Access Compliance Report

Public Rights-of-Way

(Pedestrian Signals)

Intersection ID: N/A	Main Street:	Cross Street: N/A	Location: N/A
ADA ID: 0DF52EFE72B8	Signal Type: One Push Button-APS	Overall Compliance: No	Severity Score: BTN 1: N/A BTN 2: N/A No BTN: N/A
Codes/Mitigation Info/Possible Solution		Field Measurements/Component Compliance

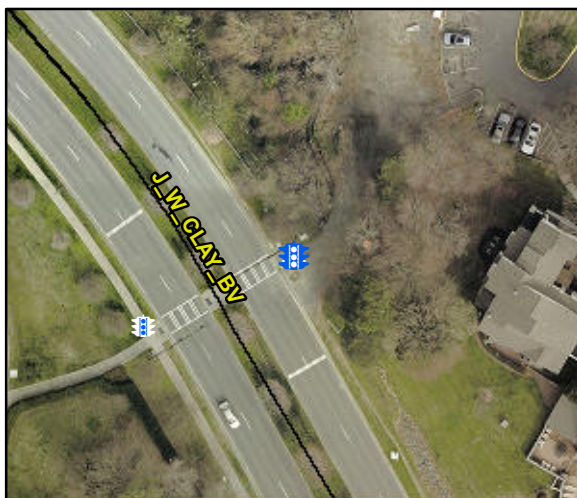
PROW/ADA: TMUTCD 4e.08, R404.2, R404.3, R404.7.2, R209.1, MUTCD 4e.10

N/A	B 1 FWD Approach Width (in)	N/A	N/A	B 2 FWD Approach Width (in)	N/A
N/A	B 1 FWD Approach Obstruction?	Yes	N/A	B 2 FWD Approach Obstruction?	N/A
N/A	B 1 FWD Approach Obstruction Dist (in)	4.0	N/A	B 2 FWD Approach ObstructionDist (in)	N/A
N/A	B 1 PARA Approach?	Yes	N/A	B 2 PARA Approach?	N/A
N/A	B 1 PARA Approach Constrained?	Yes	N/A	B 2 PARA Approach Constrained?	N/A
Yes	B 1 PARA Approach Reach (in)	6.0	N/A	B 2 PARA Approach Reach (in)	N/A
No	B 1 PARA Approach Width (in)	48.0	N/A	B 2 PARA Approach Width (in)	N/A
N/A	B 1 PARA Approach Obstruction?	Yes	N/A	B 2 PARA Approach Obstruction?	N/A
N/A	B 1 PARA Approach Obstruction Dist (in)	4.0	N/A	B 2 PARA Approach ObstructionDist (in)	N/A
No	B 1 Clear Floor Space Slope (%)	2.9	N/A	B 2 Clear Floor Space Slope (%)	N/A
No	B 1 Clear Floor Space XSlope (%)	4.0	N/A	B 2 Clear Floor Space XSlope (%)	N/A
N/A	B 1 PAR Slope (%)	N/A	N/A	B 2 PAR Slope (%)	N/A
Yes	B 1 Height (in)	38.0	N/A	B 2 Height (in)	N/A

N/A B 1 Clear Xing Direction?	Yes	N/A B 2 Clear Xing Direction?	N/A
B 1 Crossing Direction	To SW	B 2 Crossing Direction	N/A
Yes B 1 DistanceTo XWalk (in)	0.0	N/A B 2 DistanceTo XWalk (in)	N/A
No B 1 DistanceTo Curb (in)	13.0	N/A B 2 DistanceTo Curb (in)	N/A
Yes B 1 Diameter (in)	2.0	N/A B 2 Diameter (in)	N/A

Possible Solutions: Replace Signal Push Button With APS Button on New Post. Remove & Relocate Sign.
